BID PACKAGE NUMBER: 2025-0801

PROJECT NAME: GOLDEN PLAINS UNIFIED SCHOOL DISTRICT – TRANQUILLITY HIGH SCHOOL – AQUATIC CENTER SITEWORK

ADDENDUM NO. 03

EXHIBIT H

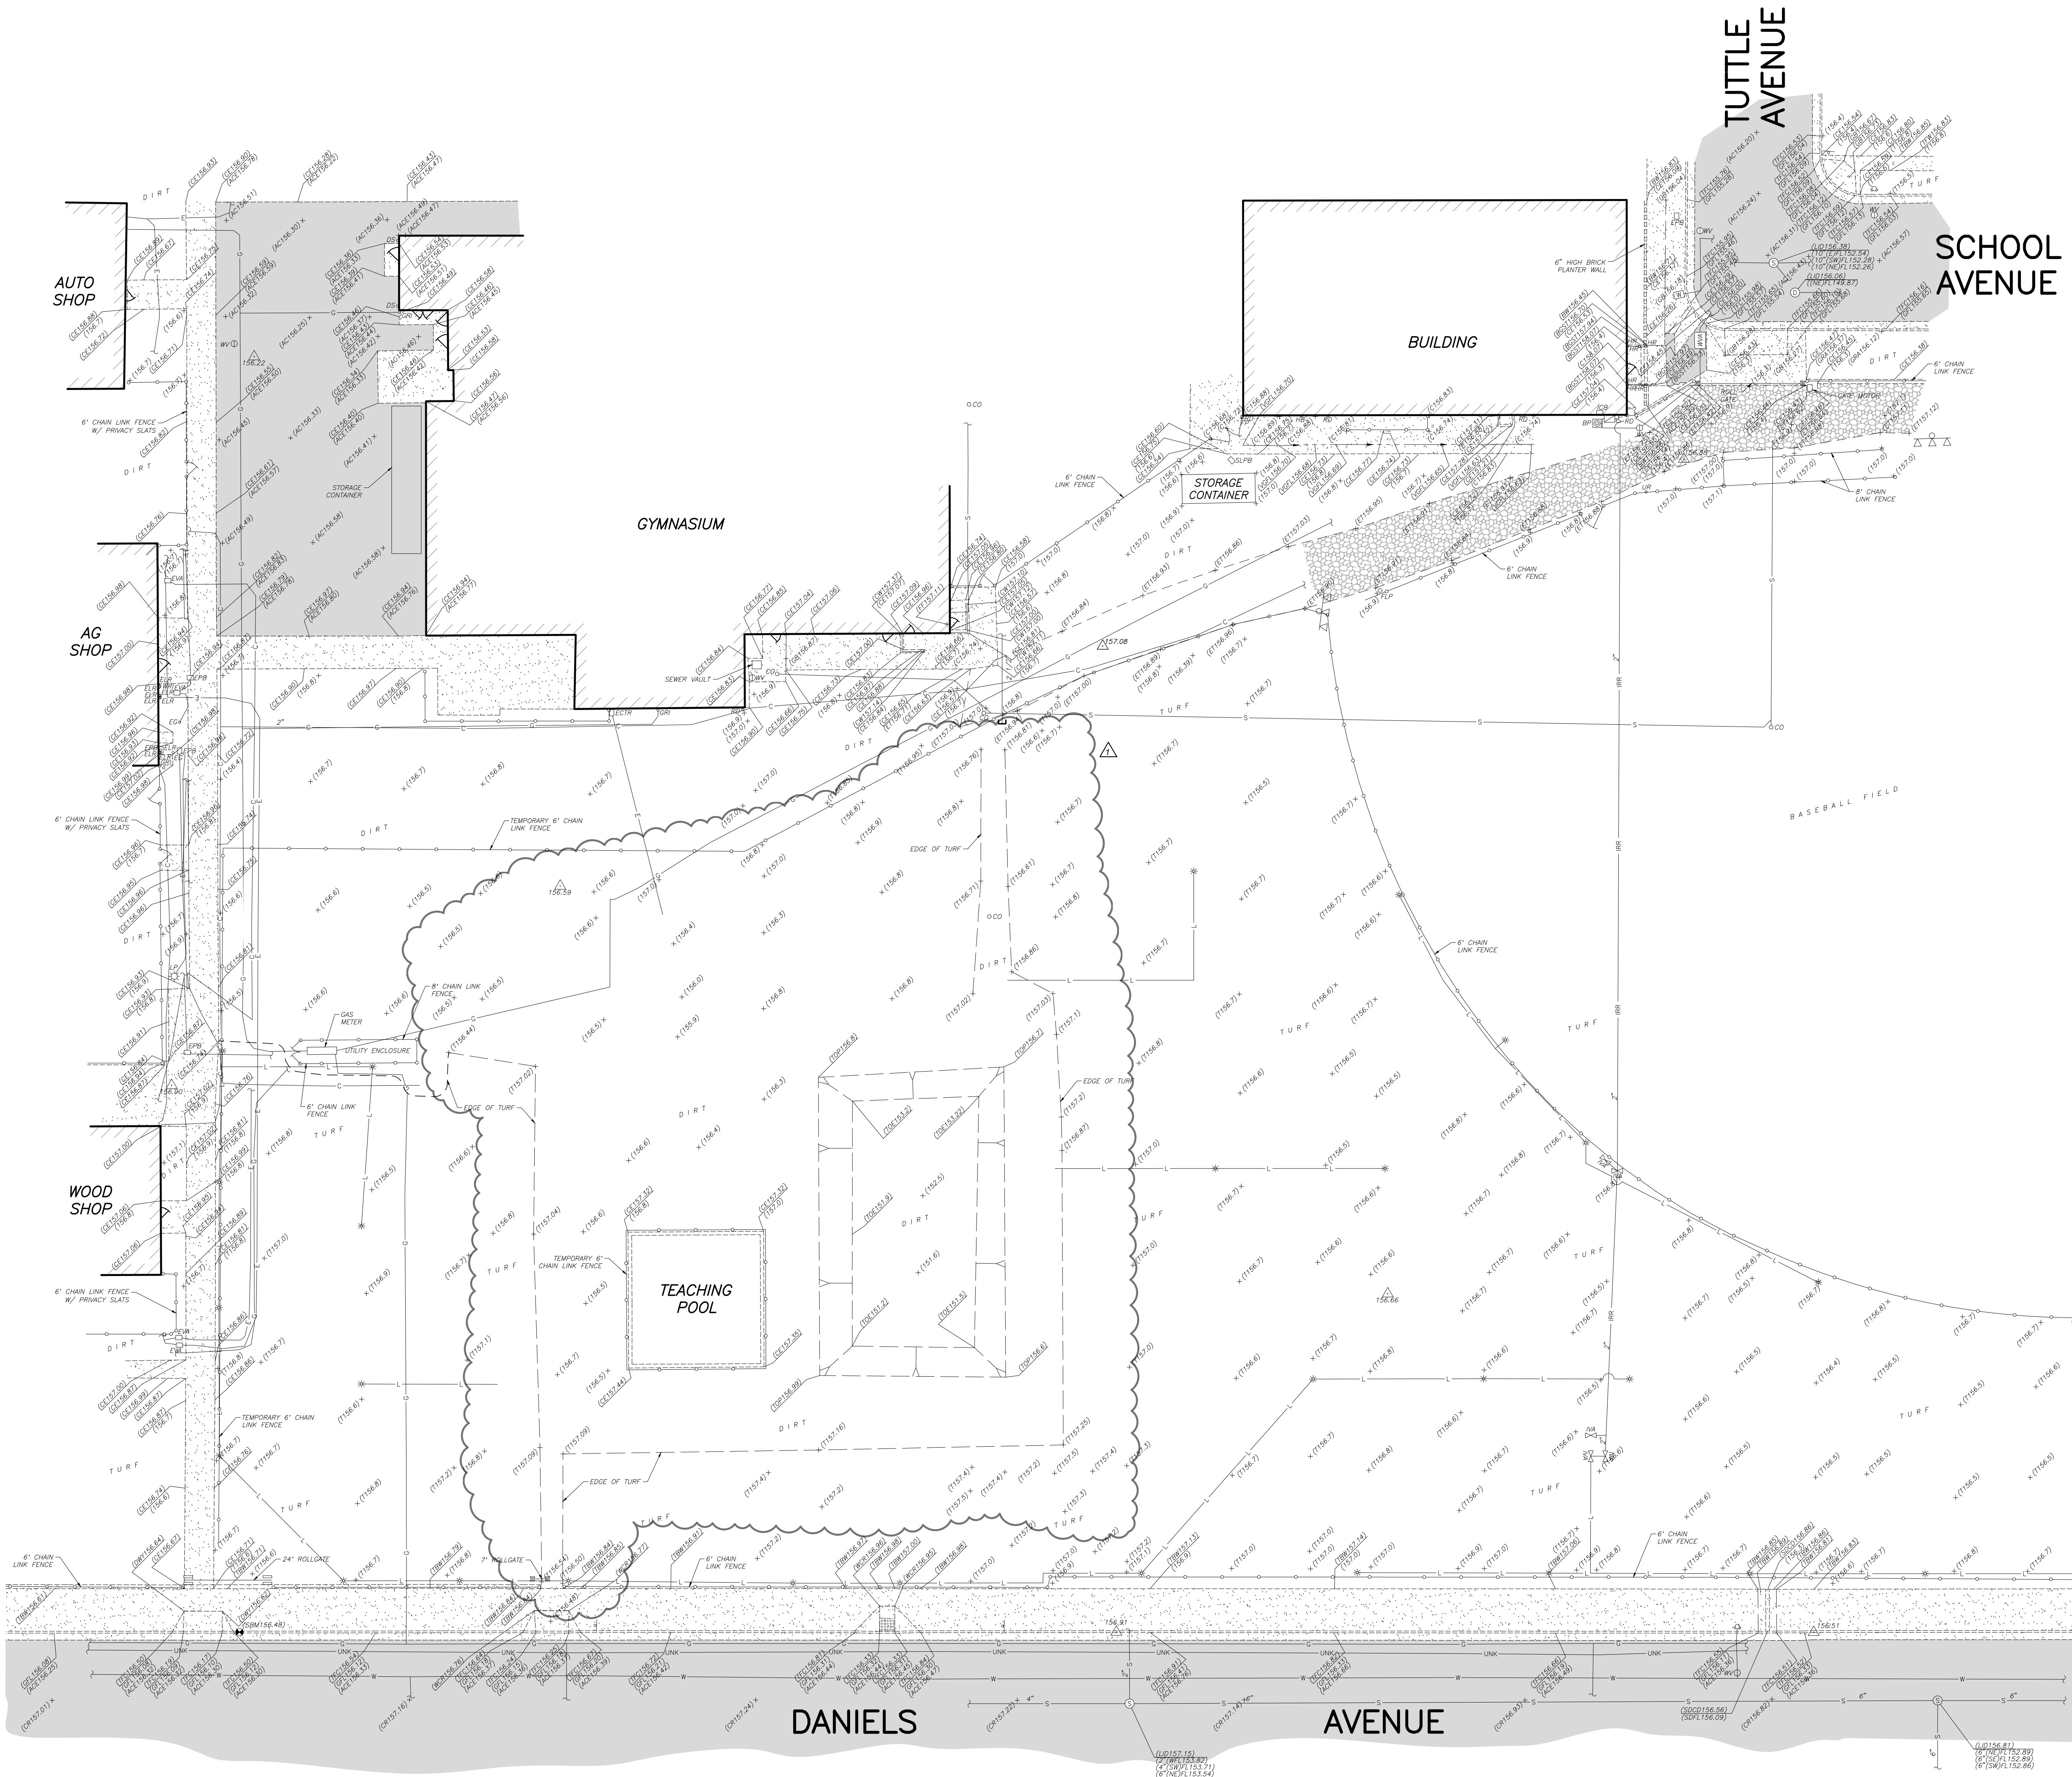
RFI-001: Please provide an actual existing topographic plan showing what has been and has not been removed, demolished or excavated. As an example demo for the existing teaching pool required for installation of piping, removal of existing pool piping, removal of existing electrical, removal of existing foundations, etc. inefficient.

Response: Please see attached updated topographic plan under Exhibit H

EXHIBIT J

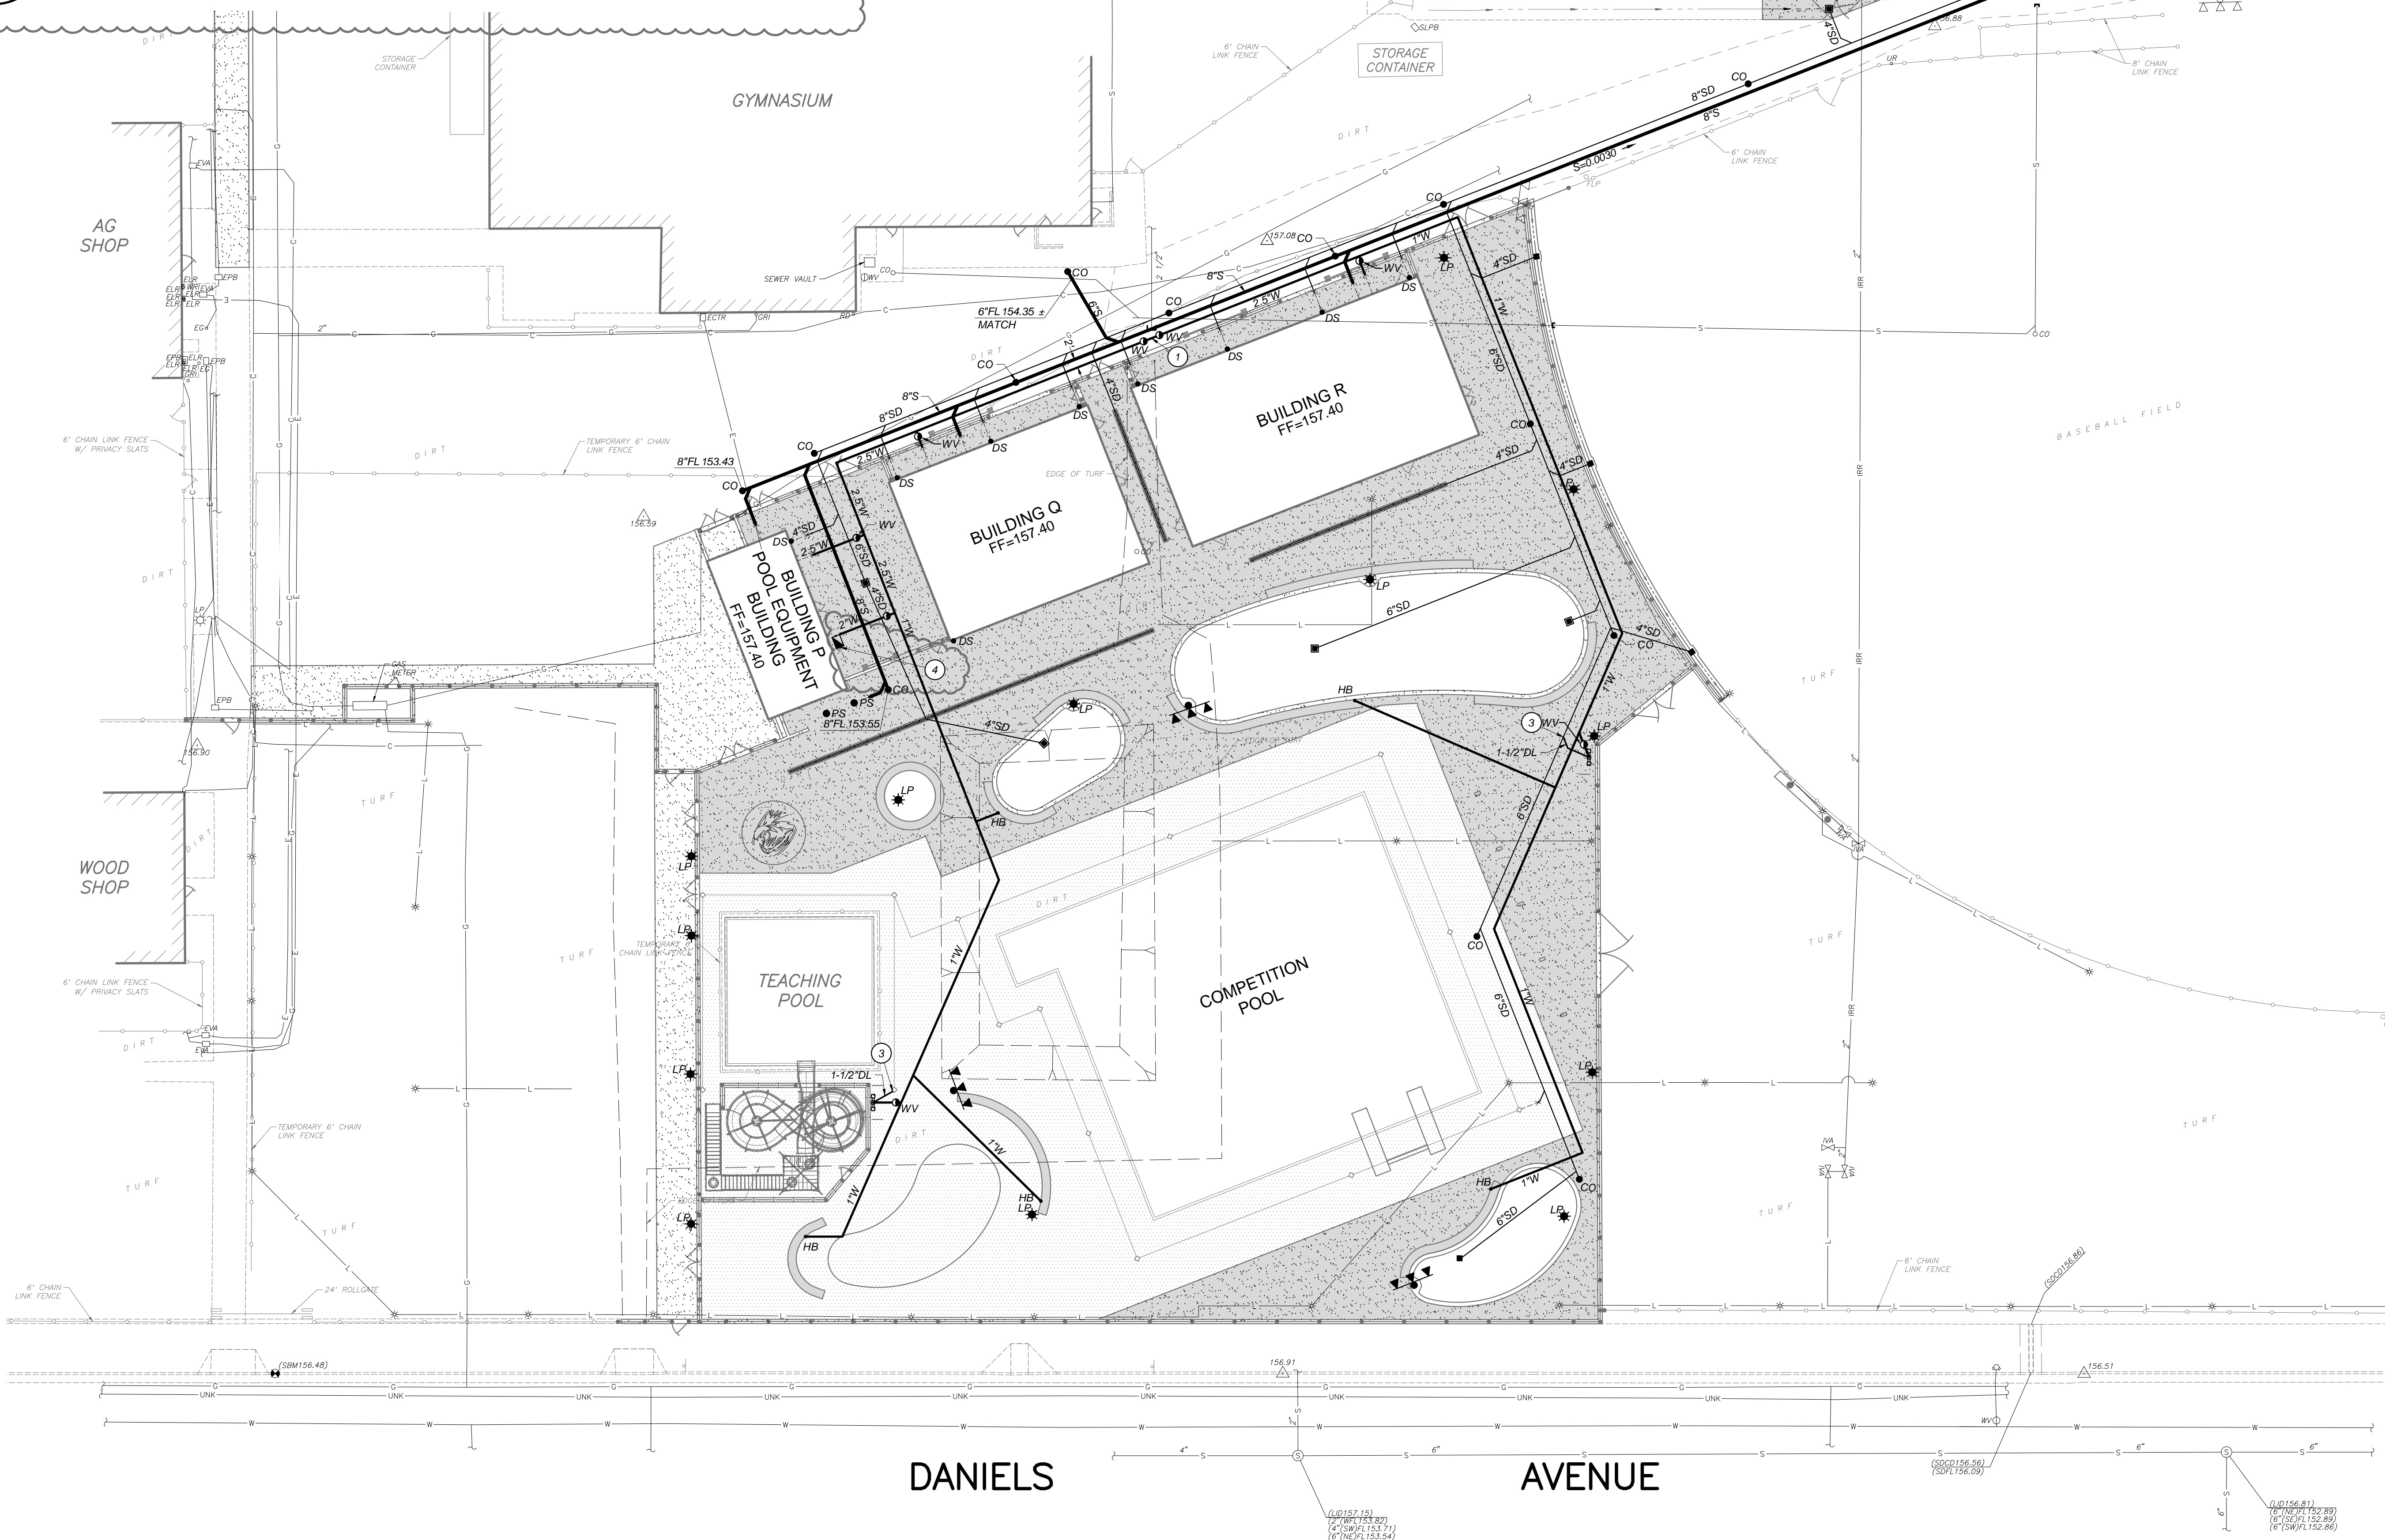
RFI-018: At the pool slide area the pool drawings call for the need for water to stub to this location, however, the civil drawings do not show any water to this location and neither did the pool drawings. Please advise how this area will be served with water as required by the pool drawings.

Response: The teaching pool has an 3/4" autofill water line that connects to the supply line head out connection of the backflow preventer located at the equipment room. A backflow preventer shall be installed on the northerly side of Building P as shown on the attached Utility Plan, Sheet C6.01-1. See supplemental drawing for added back flow preventer and water connection Exhibit 'J'.
